### **DESIGN REVIEW BOARD APPLICATION**

156 Lt George Lee Ave.

### 156 LT GEORGE W LEE AVE EXTERIOR IMPROVEMENTS -DESIGN DETAILS

Design Review Board (DRB) Application

**STOREFRONT**

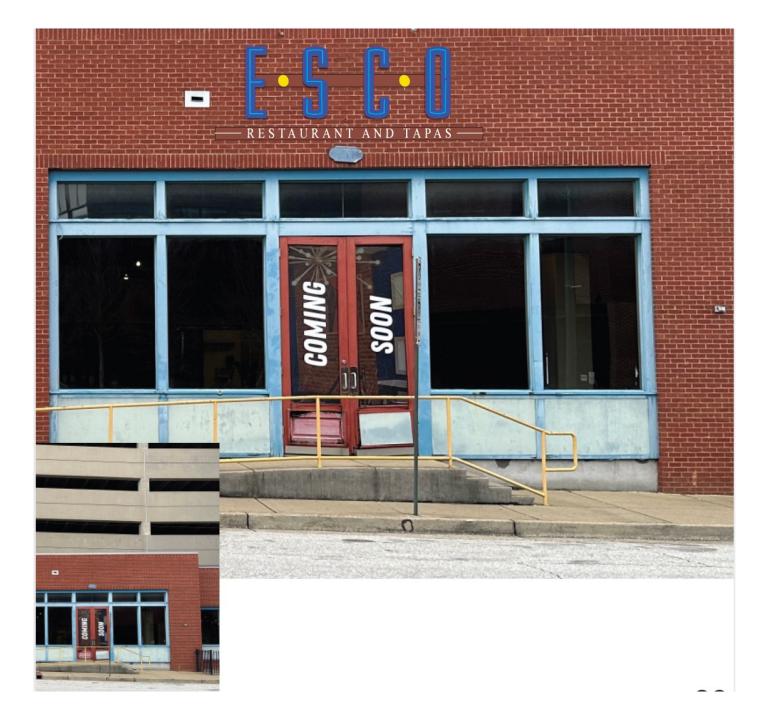
• Can you provide more details about the storefront? Is it anodized aluminum, etc.?

The store front will look like the new rendering, except the with the steel inserts, which range from 42in x 18in to 63in x 28.5in in size. The railing system will be a black powder coat. The Steel inserts will have the ESCO logo center to give it a sleek design feature.

The existing glass in the store front is 90in x 48in in size and 3/4in thick. The trim around the windows will be replaced with new wood and painted black. The paneling below those windows is 32in x 32in in size, and we still plan to give it a glass facade.

The front doors are 10ft tall with large glass centers which are approx. 5.5ft in length and 2.5ft in width on each side. The front doors will have 3ft-4ft, black metal handles.

### PATIO PERGOLA

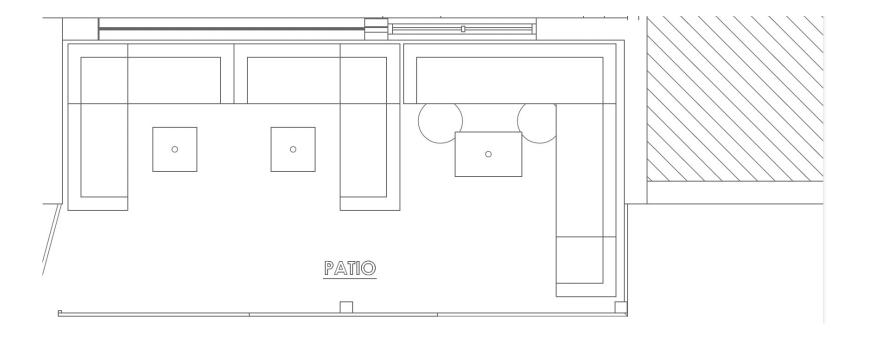
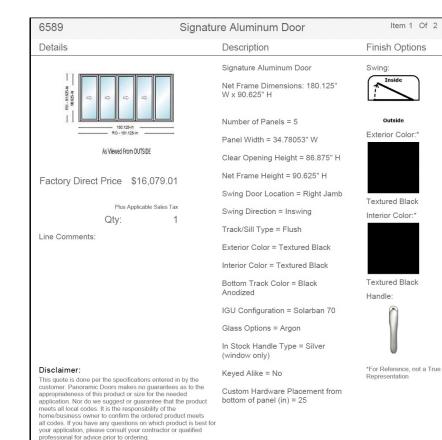
• Some of the patio pergola details were not finalized. Will you use louvers or logo routed metal plates on the railing?

It will be the logo mounted steel plate inserts for the railing of the patio. The plates will be custom fabricated to match the franchise font (logo). The sizes of the steel inserts range from 42in x 18in to 63in x 28.5in in size. The louvers were a suggestion by the architect to match the pergola louvers, but we decided not to use those for aesthetic reasons.
